ORDINANCE NO. 15-1012

AN ORDINANCE OF THE CITY OF OREGON CITY AMENDING TITLE 17: ZONING, CHAPTER 17.06.020: OF THE OFFICIAL ZONING MAP, OF THE OREGON CITY MUNICIPAL CODE, BY CHANGING THE PROPERTY IDENTIFIED AS CLACKAMAS COUNTY MAP 3-2E-07B-04100 FROM R-10 SINGLE-FAMILY DWELLING DISTRICT TO R-6 SINGLE-FAMILY DWELLING DISTRICT AND APPROVING A 25-LOT SUBDIVISION.

FILE NUMBER: ZC 15-02: Zone Change R-10 to R-6
TP 15-03: 25-Lot Subdivision

REQUEST: The applicant is seeking approval for a Zone Change from “R-10” Single-Family Dwelling District to “R-6” Single-Family Dwelling District and a 25-Lot subdivision.

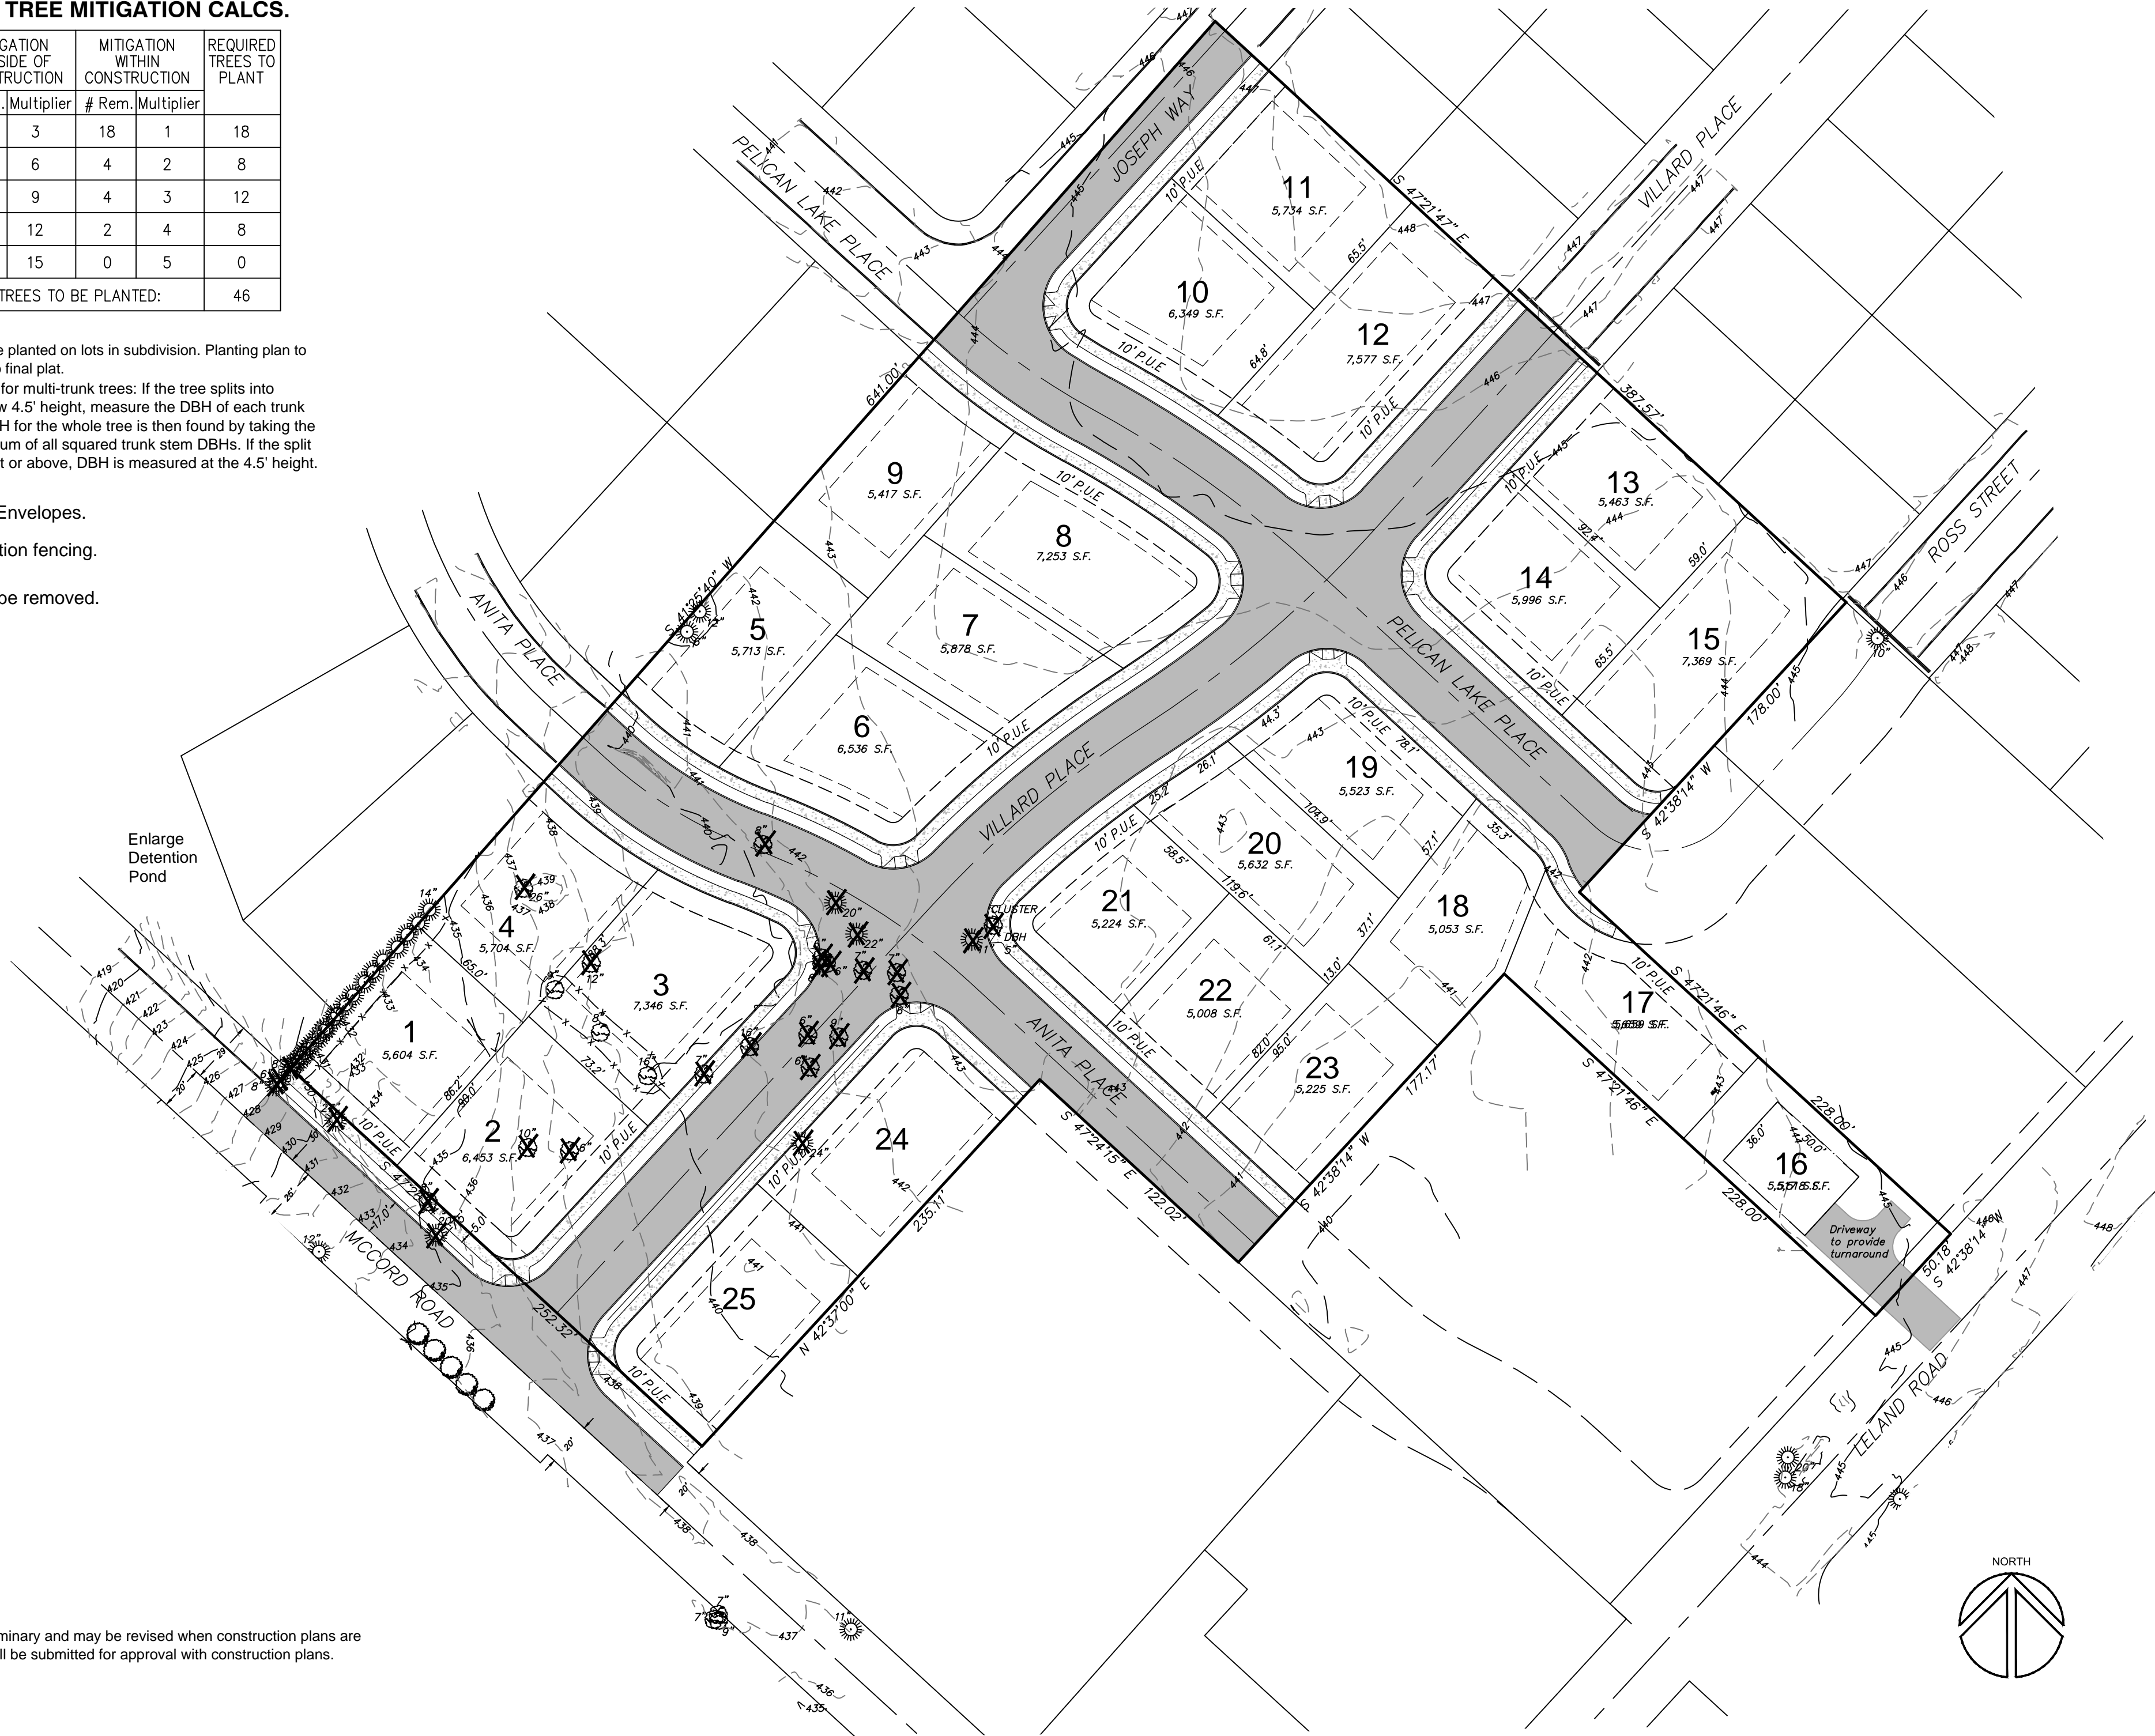
Finding: Complies with Condition. The applicant submitted a street tree plan which included trees placed along the frontages of the development. The species of the trees was not identified on the plan and the applicant indicated that “the species of street trees will be submitted for review and approval of the community development director prior to final plat approval” (Exhibit 2). Prior to issuance of a permit associated with the proposed development the applicant shall submit a plan for street trees in compliance with OCMC 12.08. **Staff has determined that it is possible, likely and reasonable that the applicant can meet this standard through the Conditions of Approval.**

45. The applicant shall submit a plan for street trees in compliance with OCMC 12.08. (P)
46. The applicant shall submit a revised tree mitigation plan in accordance with Chapter 17.41. (P)

PRELIMINARY UTILITY PLAN

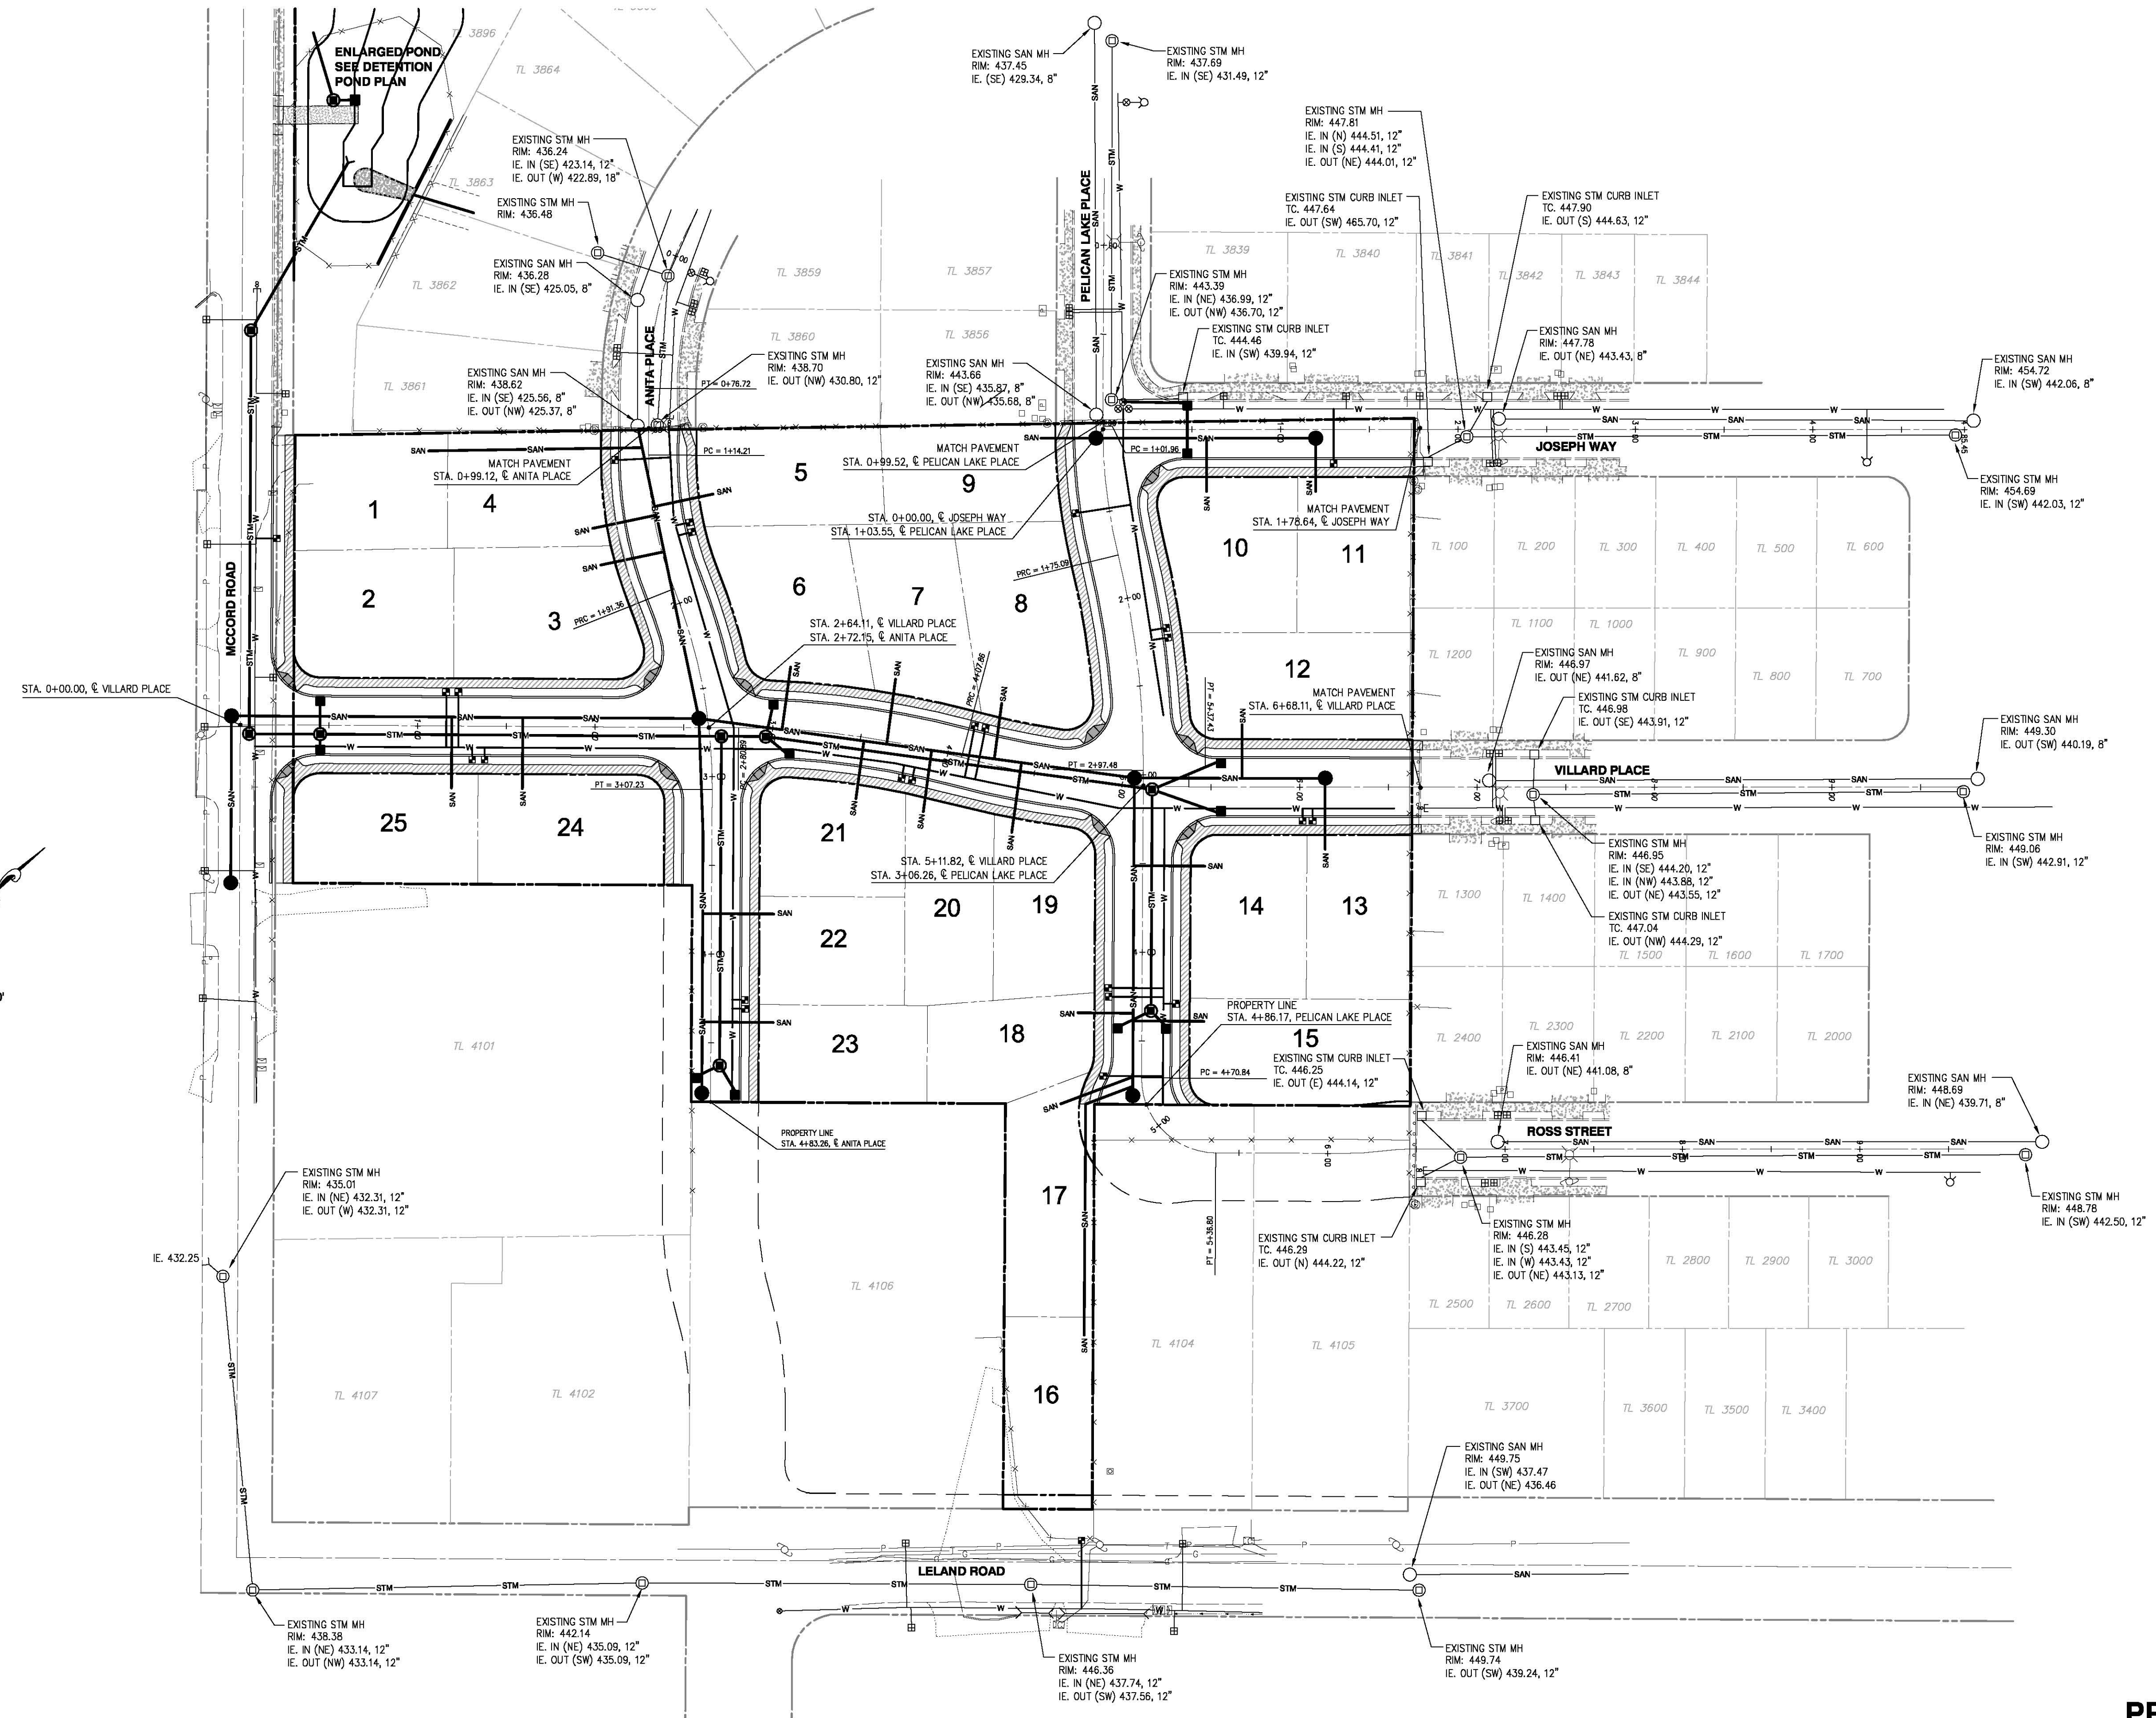
Finding: Complies with Condition. The applicant proposed extension of the existing 8-inch City sanitary sewer mains within Anita Place and at the intersection of Joseph Way and Pelican Lake Place to service the proposed lots in the subdivision. The applicant shall provide sanitary sewer laterals to all of the lots in the proposed development.

The proposed sanitary sewer main extension at the intersection of Joseph Way and Pelican Lake Road shall be extended in its standard utility location. The proposed 8-inch City sanitary sewer main on Joseph Way shall be extended as far as necessary, as determined by the City Engineer to provide sanitary sewer service to Lots 10 and 11. The sanitary sewer service connection for Lot 11 shall be made on the proposed 8-inch sanitary sewer main, and not directly to the manhole.

There is an existing 8-inch City sanitary sewer main within Villard Place. Because of existing grades, connection of the proposed 8-inch sanitary sewer mains to the existing sanitary sewer mains within Villard Place is not required. Extension of the proposed 8-inch City sanitary sewer main within Villard Place to the eastern property line is not required. The proposed 8-inch sanitary sewer main shall be extended as far as necessary, as determined by the City Engineer to provide sanitary sewer service to Lot 13. The sanitary sewer service connection for Lot 13 shall be made on the proposed 8-inch sanitary sewer main, and not directly to the manhole.

southern terminus of Pelican Lake Place. This does not meet the City's long-term plan for sanitary sewer service on Leland Road. The existing 8-inch Oregon City gravity sanitary sewer main and manhole near the intersection of Leland Road and Kalal Court shall be extended to the southwestern most boundary of the proposed development's frontage along Leland Road to provide sanitary service for Lot 16. The sanitary sewer lateral for Lot 16 shall be installed to run perpendicular to the extended 8-inch gravity sanitary sewer main within Leland Road per City design standards. The sanitary sewer service connection for Lot 16 shall be made on the proposed 8-inch City sanitary sewer main, and not directly to the manhole.

15. ☐ The new sanitary sewer system will be designed with minimum 8-inch sanitary sewer mains throughout the site, and provide stubs where needed to provide adequate service to upstream future development of adjacent properties. The pipelines shall be design and constructed using the minimum grade per the City Design Standards. (DS)

16. ☐ The applicant shall provide sanitary sewer laterals to all of the lots in the proposed development. (DS)

17. ☐ The applicant shall install an 8-inch sanitary sewer main on Joseph Way as far as determined by the City Engineer necessary to provide sanitary sewer service to Lots 10 and 11. The proposed 8-inch sanitary sewer main shall be extended in its standard utility location per City standards. The sanitary sewer service connection for Lot 11 shall be made on the proposed 8-inch sanitary sewer main, and not directly to the proposed end-of-line manhole. (DS)

19. ☐ The applicant shall install an 8-inch sanitary sewer main on Villard Place as far as determined by the City Engineer necessary to the northeast to provide sanitary sewer service to Lot 13. The sanitary sewer service connection for Lot 13 shall be made on the proposed 8-inch sanitary sewer main, and not directly to the proposed end-of-line manhole. (DS)

20. ☐ The applicant shall extend the existing sanitary sewer system (manhole and main line) located at the intersection of Leland Road and Kalal Court to the southwestern most boundary of the proposed development's frontage along Leland Road to provide sanitary sewer service for Lot 16. The sanitary service lateral for Lot 16 shall be installed to run perpendicular to the extended 8-inch sanitary sewer main within Leland Road per City standards. The sanitary sewer service connection for Lot 16 shall be made on the proposed 8-inch sanitary sewer main, and not directly to the proposed end-of-line manhole. The applicant will not be required to extend the sanitary sewer main on Leland Road if they can demonstrate, to the satisfaction of the City Engineer, that all upstream, undeveloped properties that abut Leland Road can be served from

COA # 21

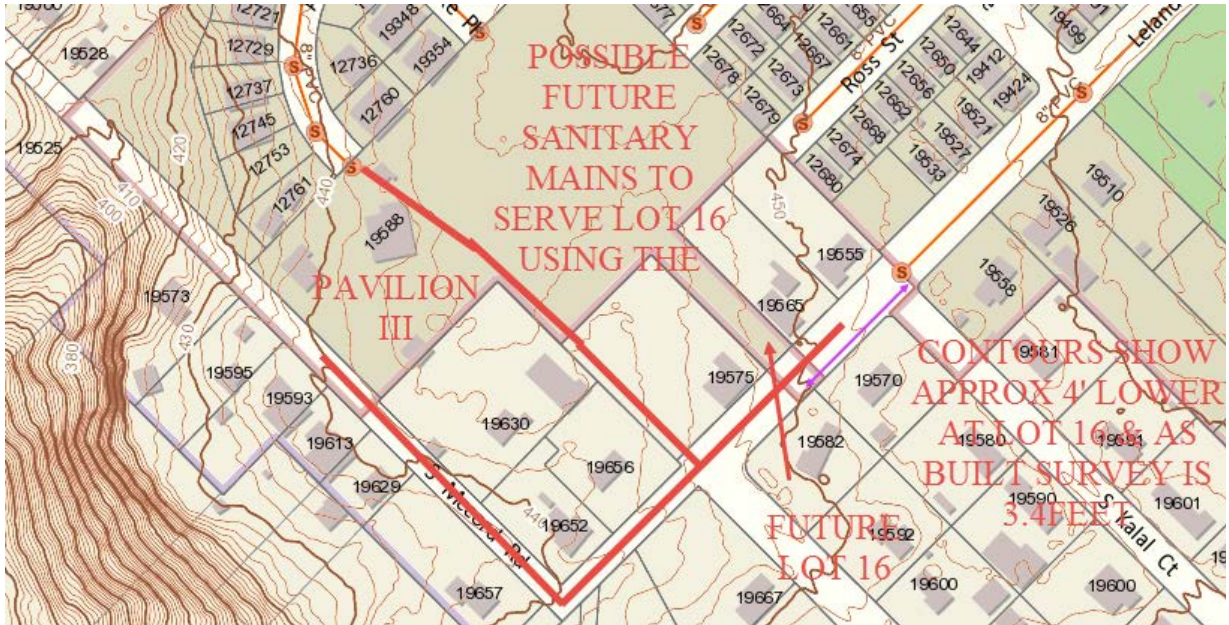
The as built elevation of the manhole at Leland and Kala Court has a rim of 449.75 with IE in of 437.47. The ground elevation in Leland Road slopes westerly with an elevation opposite future lot 16 of 446.36. The existing ground continues to slope westerly. Future mains from McCord or from Pavilion III would serve this area.
